**RESPONSE TO THE OHIO ENVIRONMENTAL PROTECTION AGENCY COMMENTS ON
SILOS INFRASTRUCTURE PROJECT DESIGN PACKAGE**

**SILOS INFRASTRUCTURE DESIGN PACKAGE
RESPONSE TO OEPA AND U.S. EPA COMMENTS**

| | Prepared By/Date DJ WHMSH - 9/28/98 | FIGURE 1 |

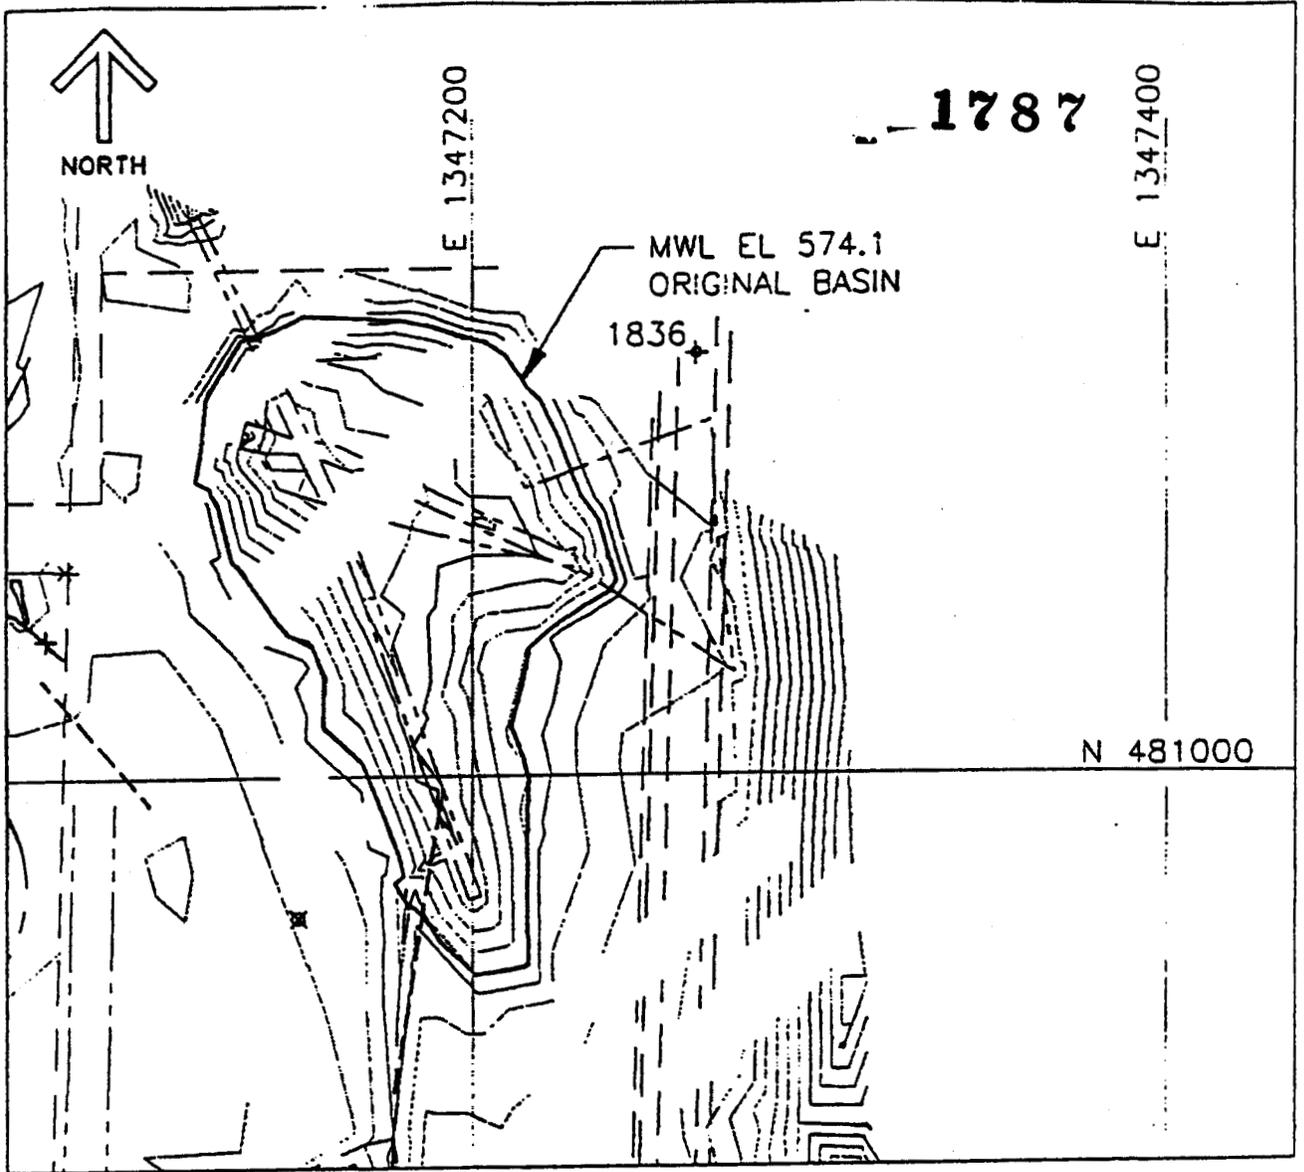
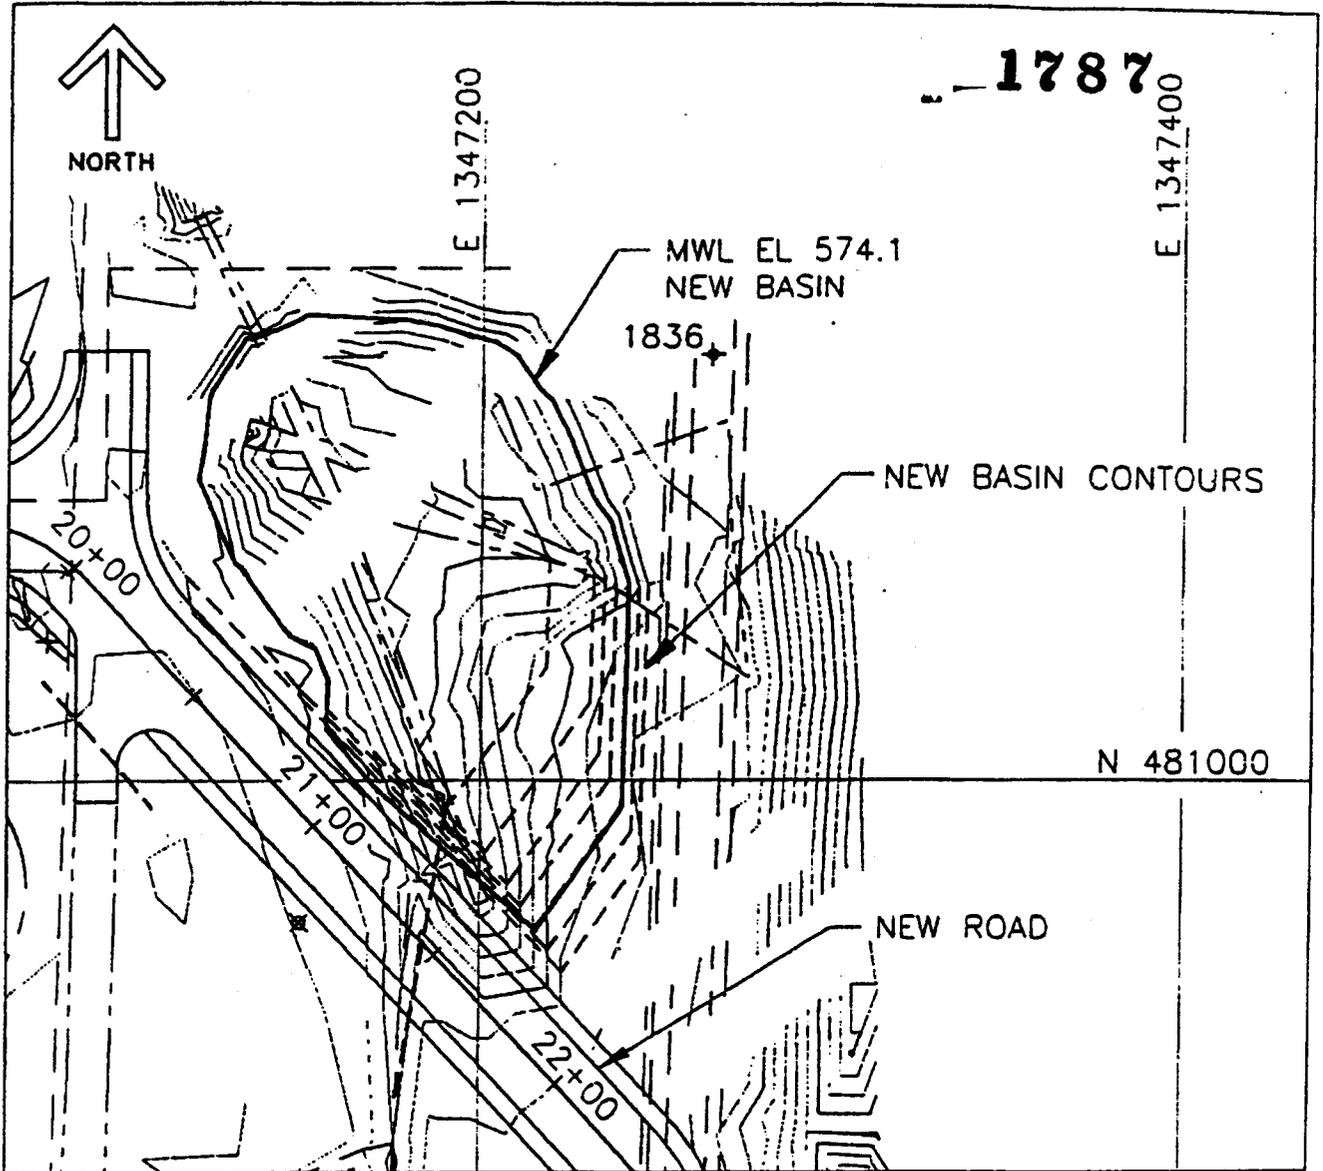
| Response: Agreed | | | |
|--|--------------------|----------------------|---------------|
| Comment: This figure shows both filling and excavation within a basin in the northern portion drawing. The specifications do not address this activity. Additional details and calculations should be provided regarding this cut and fill operation. | | | |

| Response: Agreed | | | |
|--|--------------------|----------------------|---------------|
| Response: The volume of the basin both before and after modification was calculated using Softdesk, which is an add-on to Auto Cad. The program calculates a terrain model based on topographical information from the design drawings. It then uses a triangulation method to calculate volume on a point count every 6 inches. The | | | |

program then sums these point volumes to obtain the total volume of the basin. The calculations for this portion of the design indicate a net gain of 136 cubic yards in basin volume due to the modification as part of the Silos Infrastructure Project.

JAY, ATTACHED ARE THE SKETCHES OF THE POND BEFORE AND AFTER MODIFICATION.

VOLUME BEFORE = 1406 CY TO OVERFLOW

VOLUME AFTER = 1542 CY TO OVERFLOW.

NET GAIN = 136 C.Y.
